> Product Change Notification (PCN)

Product group:	SEMITRANS	Rev.:	0
No.:	PN22-039	Auxiliary contacts of SEMITRANS 2: Partial change on surface plating	31 Mar 2022

Subject of change: The plating areas of the surfaces of the auxiliary contacts will be changed partially.

SEMITRANS 2 housing with auxiliary contacts

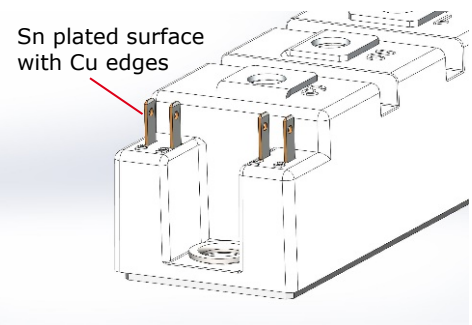
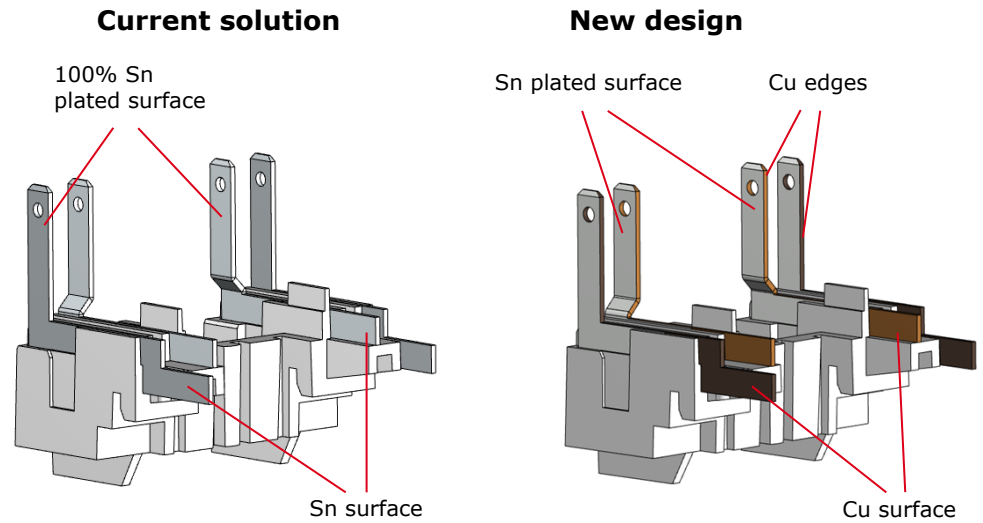
100% Sn plated surface

Sn plated surface with Cu edges

The edges of the auxiliary contacts are not tin plated any longer.
